CBD SOUTH PRECINCT DEVELOPMENT PLAN

TAS-CYP-CBS-ZWD-PLA-XLP-TSC-X0001

REV K AMENDMENT – MINISTERIAL SUBMISSION

Friday, 25 October 2024

Figure 1: Development Plan consultation process (blue refers to Early Engagement, orange refers to Public Display Period, and green refers to Stakeholder Engagement during detailed design)

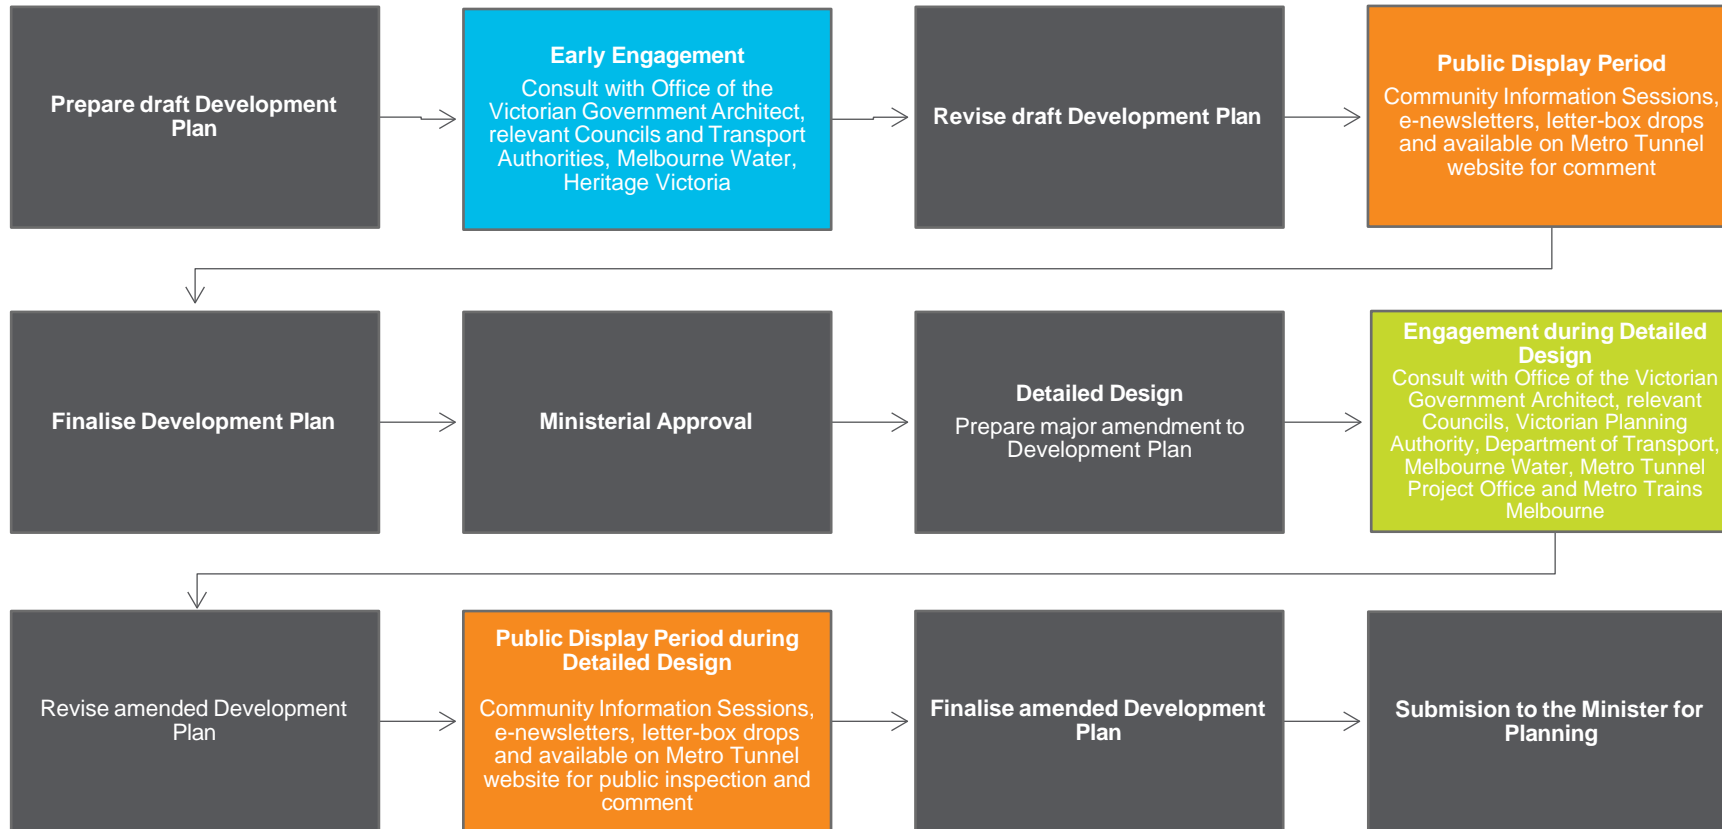
1.3.2 Stakeholder engagement during detailed design	New section added to outline stakeholder engagement post-Ministerial Approval of this CBD South Precinct Development Plan, and during detailed design
Figure 1	Updated to include the additional consultation process post-Ministerial Approval of this CBD South Precinct Development Plan
Figure 3	Figure updated to reflect the revised design

Figure 4: CBD South precinct components and station entries

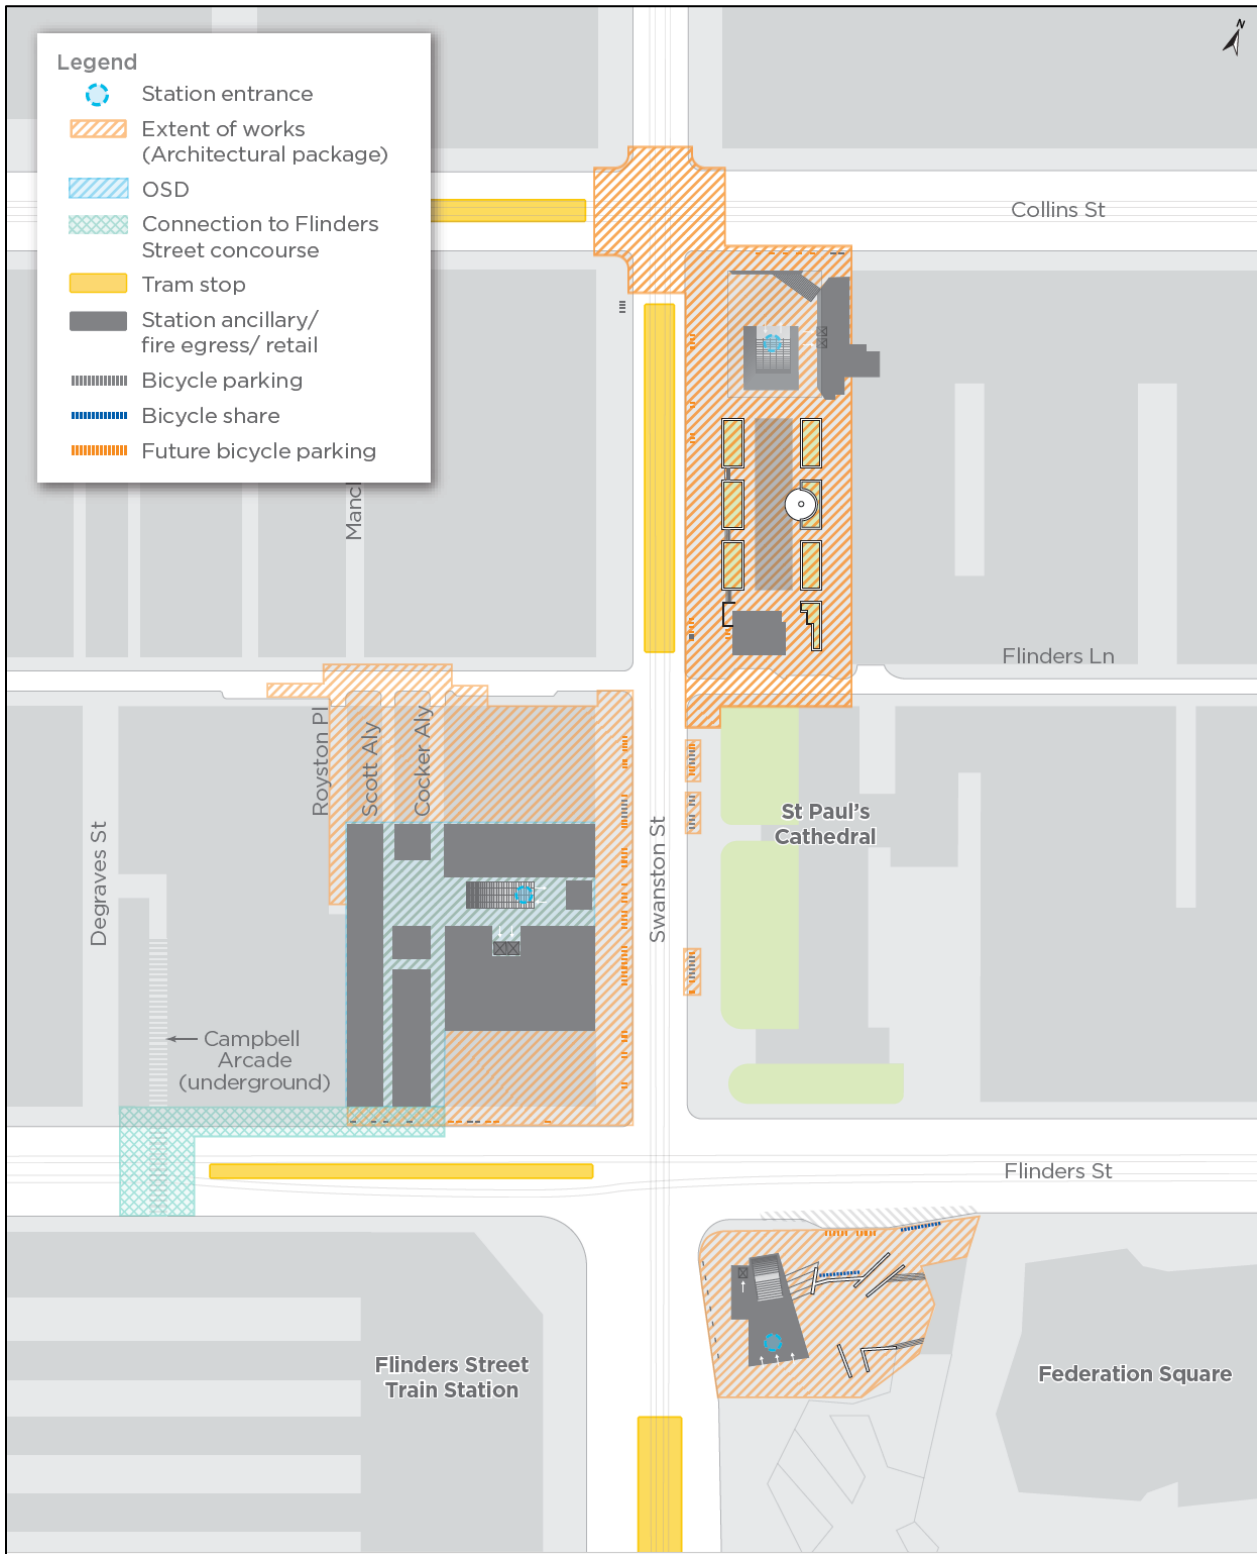
4.1 Design development	Updated to reflect that some amendments have been made to the design since the approval of this CBD South Precinct Development Plan by the Minister for Planning Details have been added regarding the amendments including a list of changes to the architectural layout, landscape design and public realm components of the Project Changes can be found in Appendix B: Architectural Plans, Appendix C: Landscape Plans and Elevations and Appendix D: Public Realm Plans.
Figure 4	Figure updated to reflect the revised design

Figure 5: Town Hall Station – entry on corner of Flinders and Swanston streets

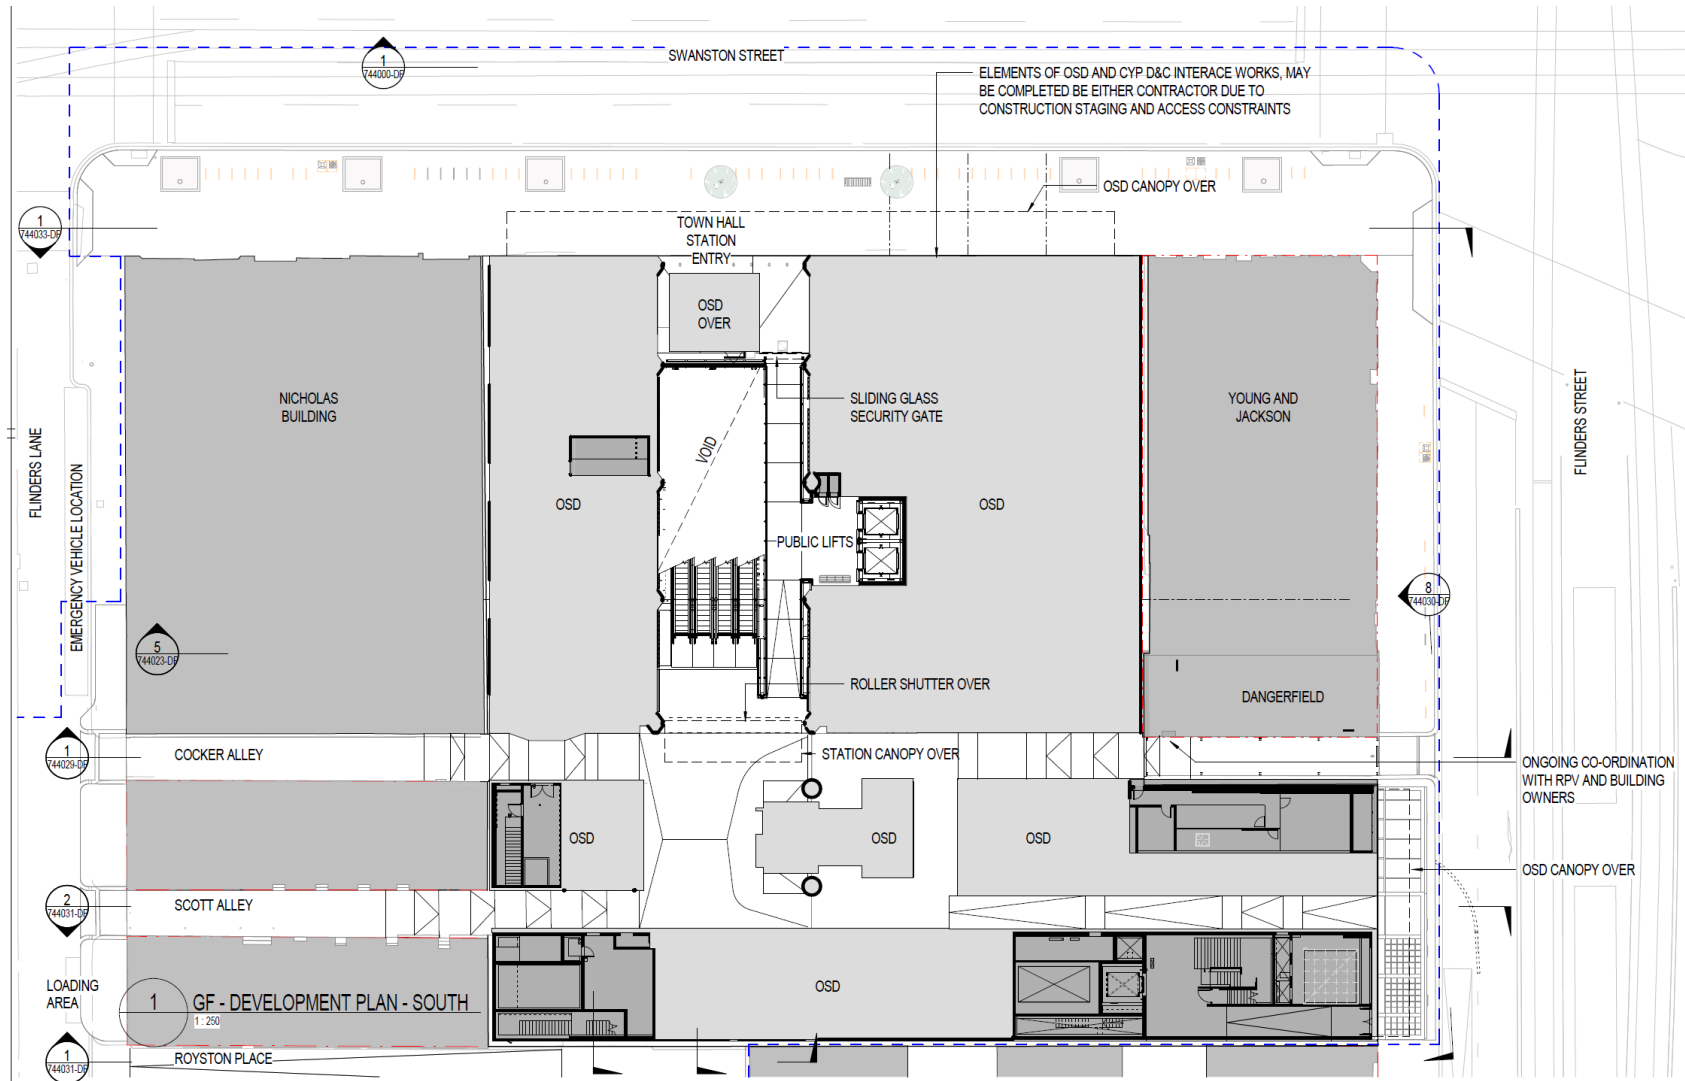
<p>Figure 5</p>	<p>Figure updated to reflect the revised design</p>
<p>Figure 6</p>	<p>Figure updated to reflect the revised design</p>
<p>Figure 7</p>	<p>New figure provided to show the layout of the Federation Square entry</p>
<p>4.3.2 Landscape response</p>	<p>Updated to reflect changes to the tree retention, removal and planting as part of the design development as well as changes in plant bed sizing and tree placement along the eastern side of City Square. Also includes an update on the planting concept for City Square.</p>
<p>4.3.3 Public realm response</p>	<p>Updated to outline changes to the public realm at the City Square entrance, including relocation of the reimagined Mockridge, tree planting, paving, furniture, and bike parking updates in response to the revised road and parking arrangement.</p> <p>Updated to reflect the introduction of security bollards at Federation Square and at the Flinders OSD entrance, and rainwater captured from the Federation Square station entrance roof structure has been designed to discharge into a new stormwater pit located next to the glass façade of the lift shaft. Design modification to the Commemorative Steps will also occur along the western edge of the heritage steps.</p> <p>Changes can be found in Appendix D: Public Realm Plans.</p>

Figure 12: Indicative material and finishes palette for Town Hall Station

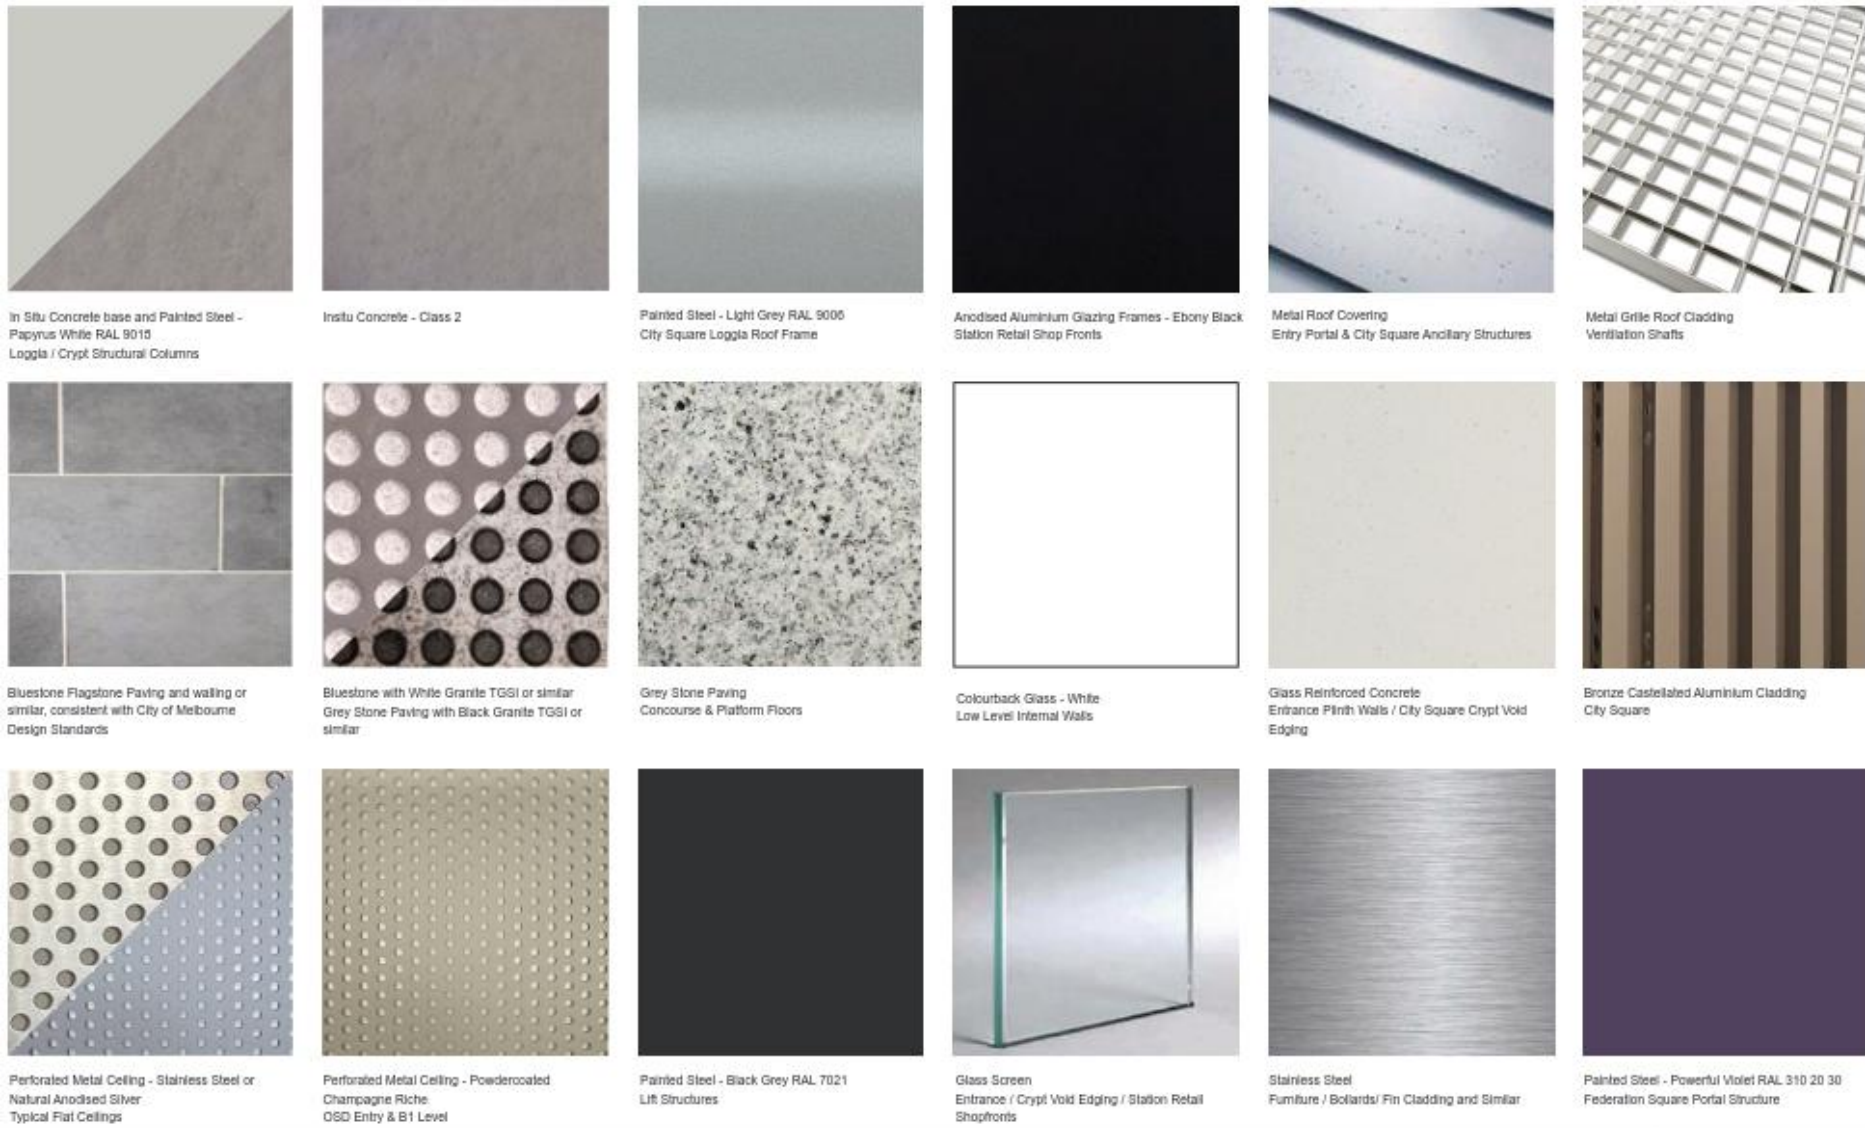
4.3.5 Lighting	Updated to outline lighting updates to City Square, including feature lighting to some of the terrace edges.
4.3.8 Materials and finishes	Updated to include detail on the addition of colour to the Federation Square entrance portal structure as a station wide colour update.
Figure 12	Figure updated to reflect the revised materials and finishes.
